City of Portland, Oregon
Bureau of Development Services
Land Use Services
FROM CONCEPT TO CONSTRUCTION

MEMORANDUM – DAR #2

Re: EA 17-269490 DA – 1724 NW Hoyt
Design Advice Request #2, Summary Memo, February 26, 2018 Hearing Date

BUILDING ELEVATION - NORTH

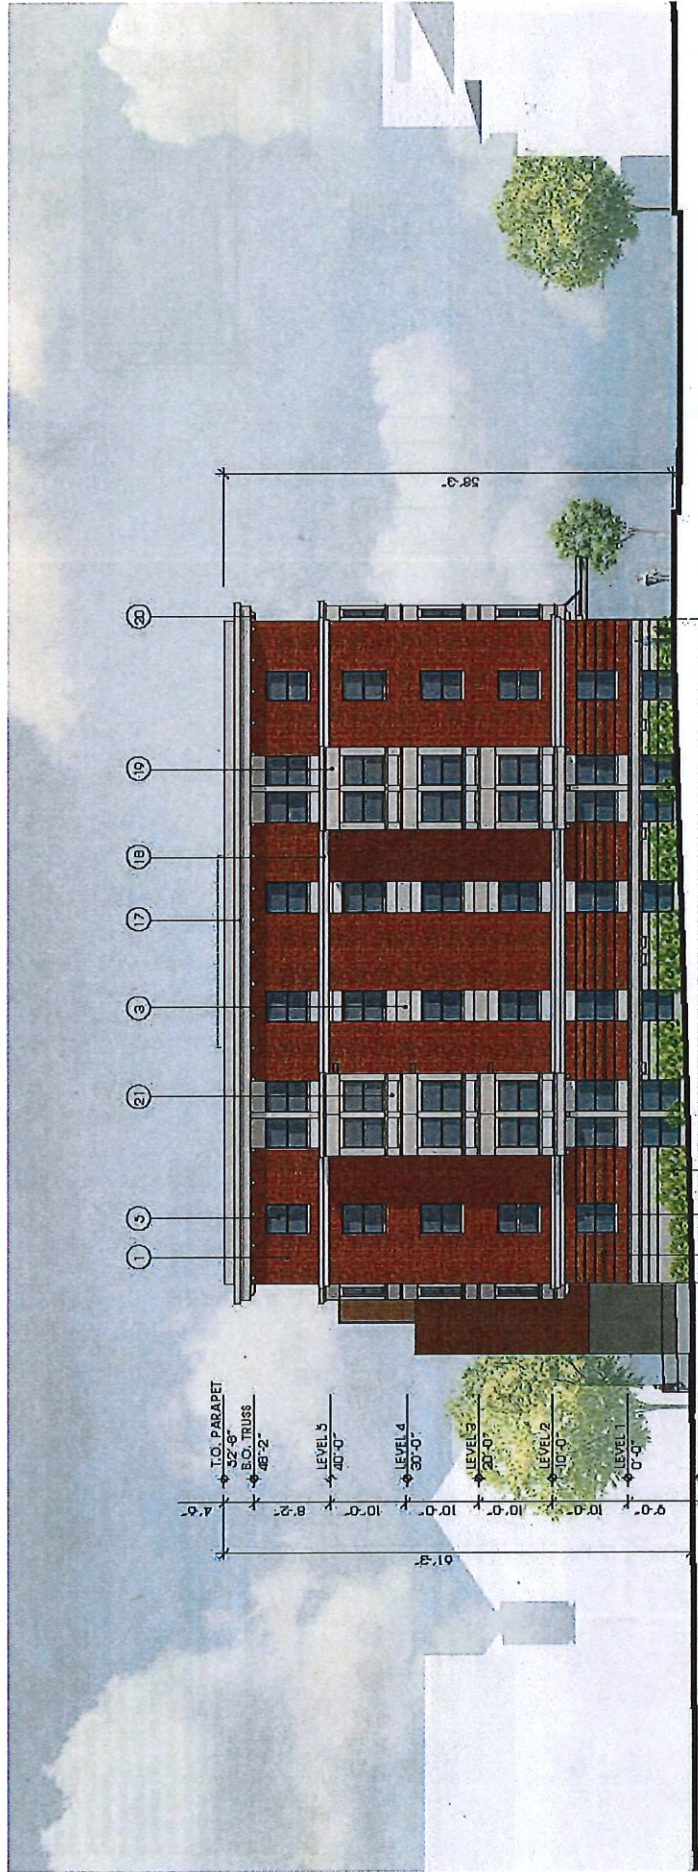
- B. **North Building.**
 1. **Height and Massing.** The Commission generally agreed that the simplified vertical massing was greatly improved from the vertically stepped proposal shown at the first DAR. However, there were remaining concerns about the overall massing. Commission response was varied as to whether the height/scale/massing of the proposal was compatible with the adjacent context of historic houses on NW Hoyt and NW Irving:

- One Commissioner noted that while the massing of the North Building has improved and is moving closer to being like something seen in the District, there needs to be a stronger response to the smaller scale on NW Irving. Consider how this might be addressed, perhaps by pushing back the central portions to provide a courtyard to break down the mass, and/or adding another entry. Note however, that just stepping back upper floors isn't typical in the district.

- Oriels. The Commission supported the squared off approach for the bays, and thought they better related to the buildings across the street, the Campbell Townhomes.
- Entry. The Commission supported the setback entry on NW 18th, and noted the massing setback helped modulate the plane of the frontage along NW 18th. The Commission was also comfortable with the depth of the setback, and a couple of the Commissioners noted they were fine with the egress wells. However, more attention is needed to show its prominence as the main entry into the building. Consider increasing the size of the entry canopy so it is larger than the entry to the BP and more proportional to the building.
